ARBORICULTURAL IMPACT ASSESSMENT

WIMBLEDON PARK PROJECT

Arboricultural Impact Assessment GLA Planning Addendum

Report Reference Number: 51365-TEP-XX-XX-RP-X-00005-S2-P01

Figure 1: An extract from the 2024 GLA Addendum Tree Protection Plan

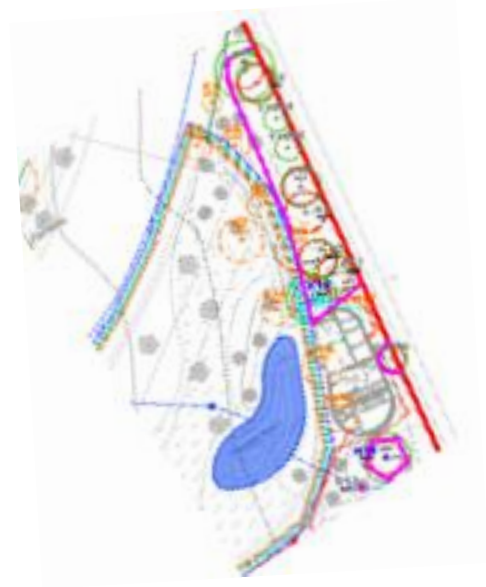
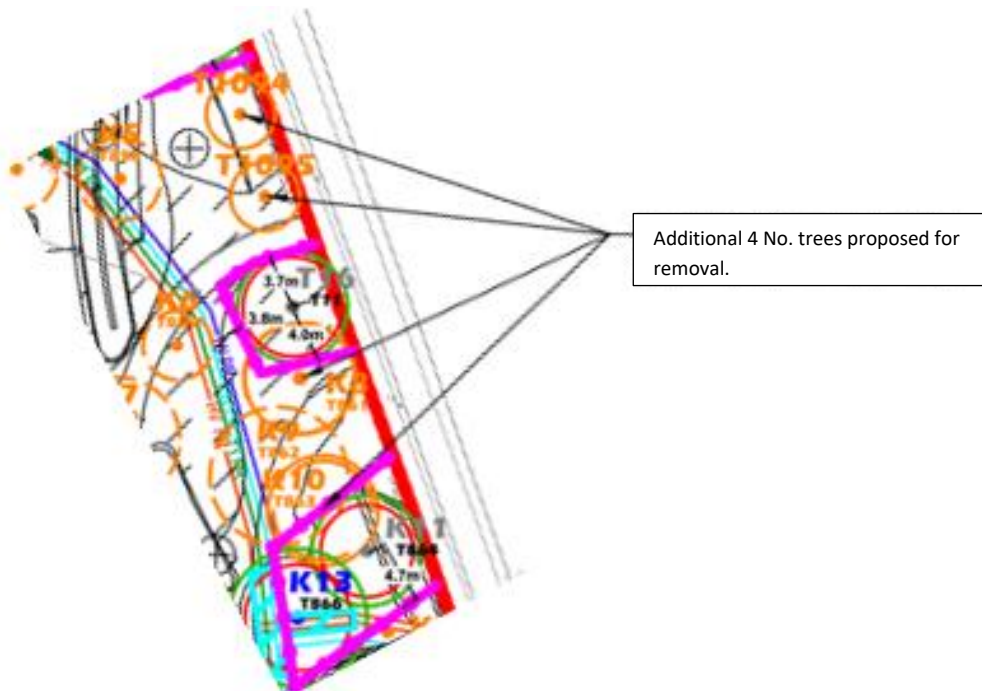
- At the original planning stage, 296 trees (28%) were identified for removal to facilitate the development and/or restore the landscape to its historic character (235 and 61 trees respectively). Of the 296 proposed tree removals, none were assessed as Category A (as defined by British Standard BS5837: 2012 Trees in *Relation to Design, Demolition and Construction – Recommendations*), 28 Category B, 252 Category C and 16 were found to be in such a poor condition with limited life expectancy that they have been classified as Category U. **An additional 4 trees would require removal** to facilitate the proposed design changes, specifically being impacted by the realignment of paths, bringing the total number of removals to 300.

- All four trees have been assessed as Category C ‘trees of low quality’. They are located within an existing hedgerow/scrub close to the site’s northeastern boundary. They are three early mature small silver birch and a bird cherry. Appendix A provides further details of the trees in the Tree Schedule.

- For ease of reference, an extract of the original (2021) Tree Protection Plan (ref 51365-TEP-XX-XX-DR-L-02151) and the updated GLA Addendum Tree Protection Plan (ref 51365-TEP-XX-XX-DR-L-02151-S2-P02) are shown as Figure 1, 2 and 3. The Tree Protection Plan page relating to this area is in Appendix B.

- Additional compensatory tree planting to offset the loss of the additional 4 trees is proposed. It is understood that off site design proposals within Wimbledon Park include additional planting, subject to S106 Agreement, as part of the package of wider improvements. It is estimated that this could include a minimum of 45 additional trees.
